Reference: Capital & Operating Cost Evaluation for LYSTEK and ANDRITZ Biosolids Processing
Systems – RFP – 28 -14; T-29-15 Merchant Capacity for Biosolids Management Services

# Memo

Capital & Operating Cost Evaluation for LYSTEK and ANDRITZ Biosolids Processing

FIGURE 1: REVISED LYSTEC BUILDING PLAN SCALE: 1: 4

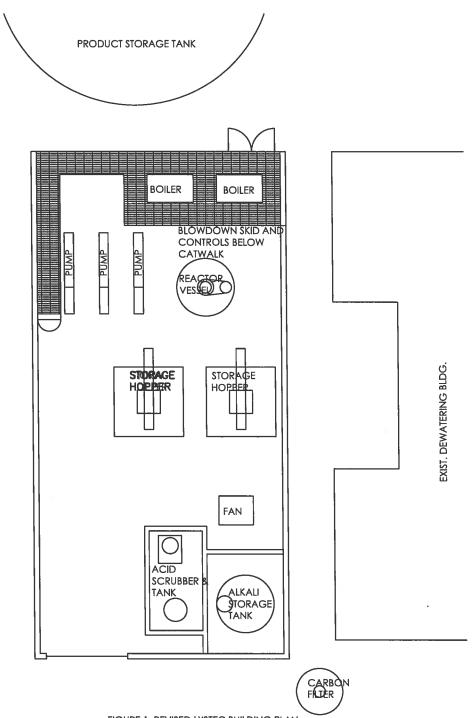
As part of the submittal the proponent provided a building layout for the proposed system. Lystek proposed a building 11m x 17m by 7.5m high. After reviewing the layout we felt the proposed configuration was insufficient for full maintenance access to the equipment. Therefore we developed an alternative layout that that requires a 11m x 22m x 10m high building. A plan of the revised layout is shown in **Figure 1**. The financial review of the system is based on the construction of the larger structure.

FIGURE 2: REVISED ANDRITZ BUILDING PLAN SCALE: 3/4" = 1'-0"

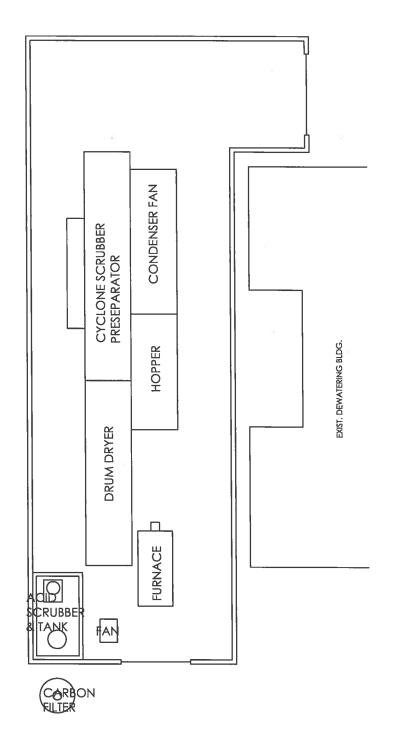
As part of the submittal the proponent provided a building layout for the proposed system. Andritz proposed an L shaped building with the main process areas sized at  $11m \times 17m$  by 11.4m high with a truck bay  $6m \times 15 m \times 11.4$  high. After reviewing the layout we felt the proposed configuration of the process area was insufficient for full maintenance access to the equipment. Therefore we developed an alternative layout for the process area of  $11m \times 27m \times 11.4m$  high. The truck bay remains the same A plan of the revised layout is shown in **Figure 2**. The financial review of the system is based on the construction of the larger structure.
